FINAL SCHEMATIC DESIGN PLAN

**WINTHROP STREET CEMETERY**  
PROVINCETOWN, MA

Re: Winthrop Street Cemetery Final Schematic Design Narrative

Winthrop Street Cemetery  
Provincetown, MA  
Community Meeting #1

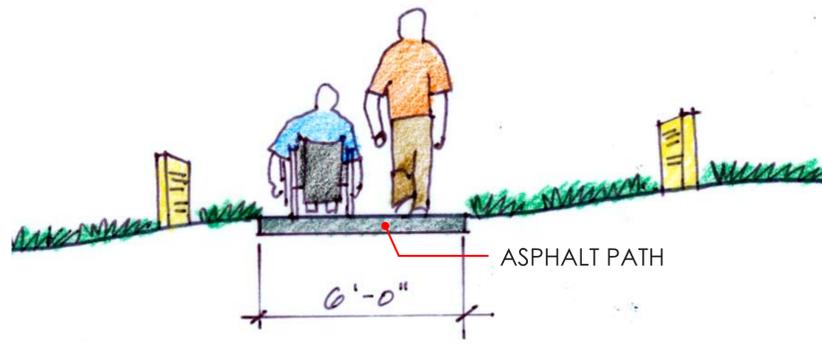
- b. Accessible Paving – Abutters were concerned with adding an asphalt path into the Cemetery. They mentioned that they may be used by bicycles or skateboarders. One abutter mentioned she was concerned with turtles not being able to cross the asphalt path. The attendees preferred a permeable stabilized stone dust path over asphalt. There was a consensus to change the path to this material. A concern was raised about stone dust eroding in big storm events. Ray stated that the stone dust paths would need to be maintained and replenished on occasion. Ray also suggested that weeds will grow into the surfacing over time.

- c. Trails – RDLA mentioned that the trails would remain as a sand surface, but edged with new plantings. We presented cross sections of the various trail designs. Unwanted trails will be blocked by temporary snow fencing. Once vegetation is established, the fencing will be removed.

- d. Court Street Entrance – One attendee was concerned about adding a new entrance to the Court Street side of the dune, thinking that it would create new erosion by foot traffic. Other attendees noted that there is an existing trail to the summit via wood stairs already. After further discussion, there was consensus to open the fence entrance on Court Street.

- f. Signage – Interpretive signage is favorable. The Historical Commission would like to be involved. New signage for the 2020 anniversary would be great. Signage like that at Kings Chapel and the Granary in Boston is acceptable. Richard mentioned Amy McGuiggan who wrote “My Provincetown” has been approached to assist in the interpretive sign narrative. The sign at the Winthrop Street entrance will be moved to allow for the new accessible path location.

- g. Fencing – Existing fencing and granite posts have been damaged by snow plows this past winter. Michelle will work with the DPW to assist the funding of the fence using shared funds. The fencing repair will be included in this construction package.
